**Village of Thiensville
Plan Commission
AGENDA**

**CHRIST ALONE 247 SOUTH MAIN STREET
CHRIST ALONE EVANGELICAL LUTHERAN CHURCH
PLAN COMMISSION REVIEW**

Re: Christ Alone Building Addition
Site Plans and Storm Water Review

BUILDING ADDITION SITE DEVELOPMENT PLANS VILLAGE OF THIENSVILLE, WISCONSIN

SHEET
C3.0

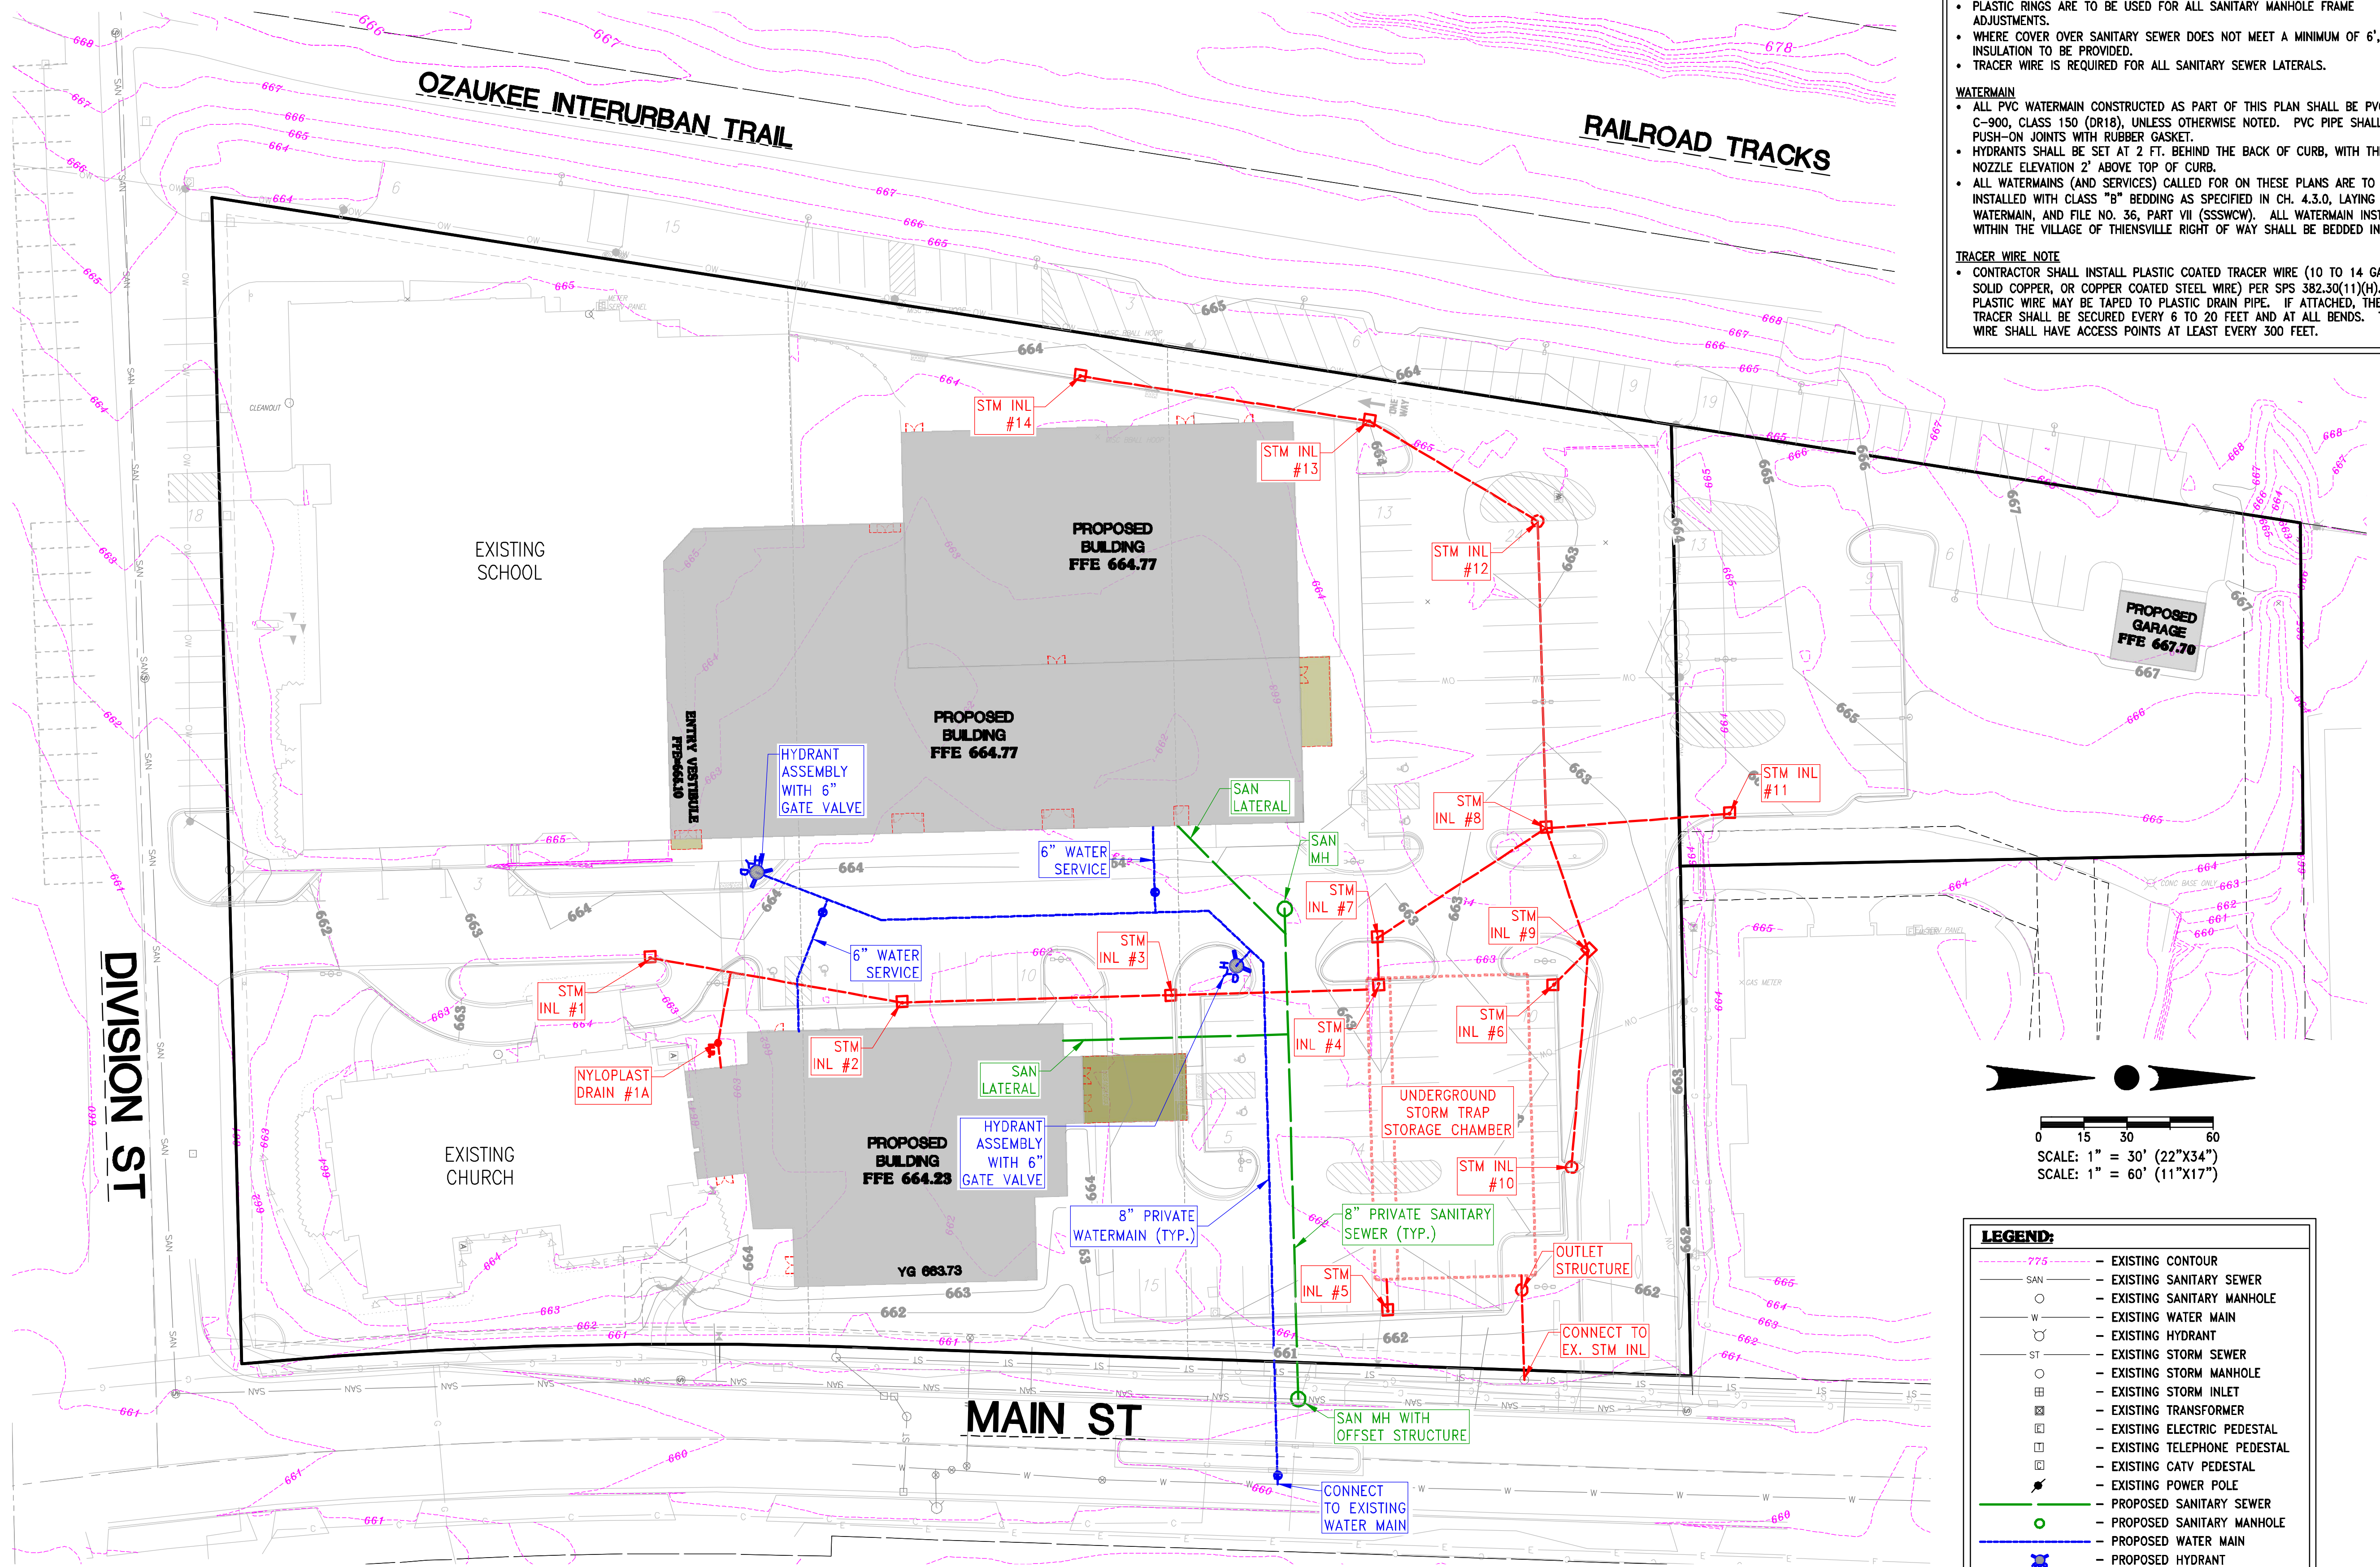
7. Plan Sheet C3.0 Erosion Control Plan:
 - a. Add to note no. 8 of the Construction Sequence Plan to contact Mequon Water Utility prior to connecting to existing water main.

- b. Include installation of underground detention system in construction sequence.
 - c. Remove reference to bio-filtration basin in construction sequence.

- d. Recommend calling out type of inlet protection on plans such that proper inlet protection is installed in the correct locations, specifically Type D inlet protection in low lying areas.

- e. Provide inlet protection to existing storm inlet on Division Street, south of existing church.
8. Plan Sheet C4.0 Utility Plan:
 - a. Revise storm sewer note for connection on Main Street to connect to "EX. STM MH" not INL.

SHEET
C1.1

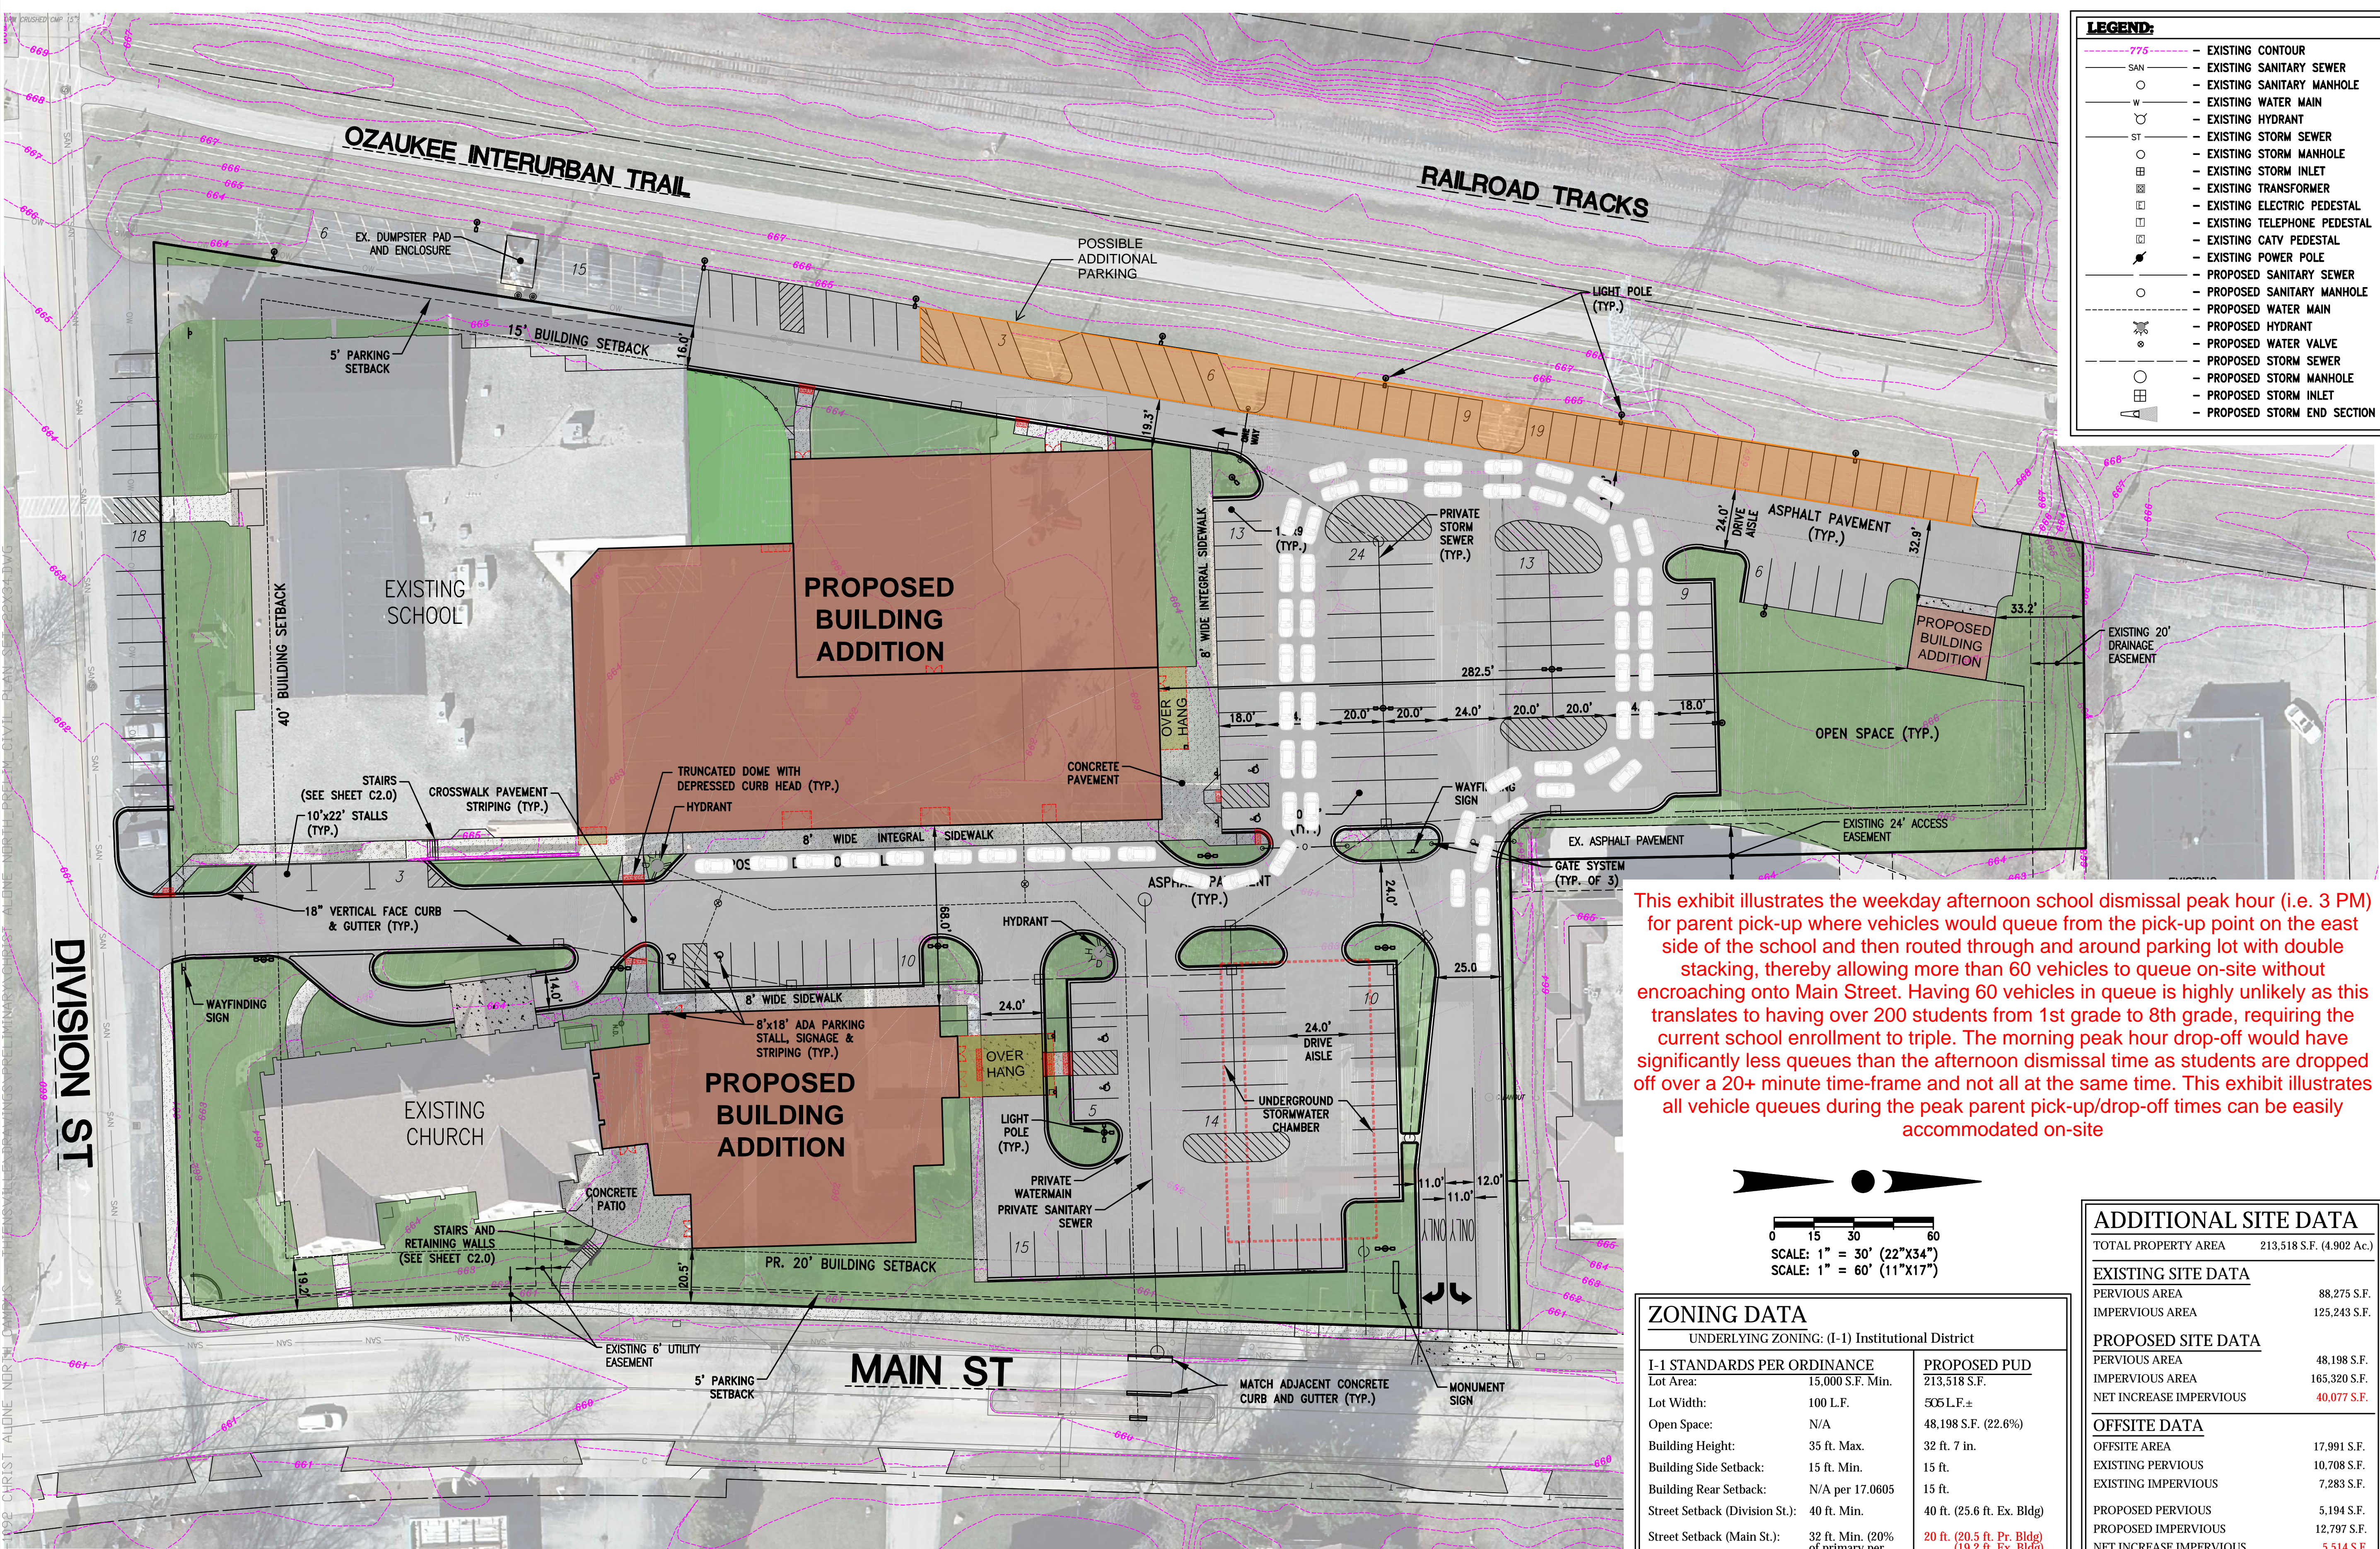
4. Plan Sheet C1.1 Proposed Site Plan:
 - a. Show concrete curb and gutter replacement of existing concrete driveway opening being removed on Main Street (south of proposed driveway opening).

- c. Based on the drawing hatch, it appears that the public sidewalk along Main Street and Division Street is being replaced. If that's not the case, the proposed sidewalk hatch should be removed.
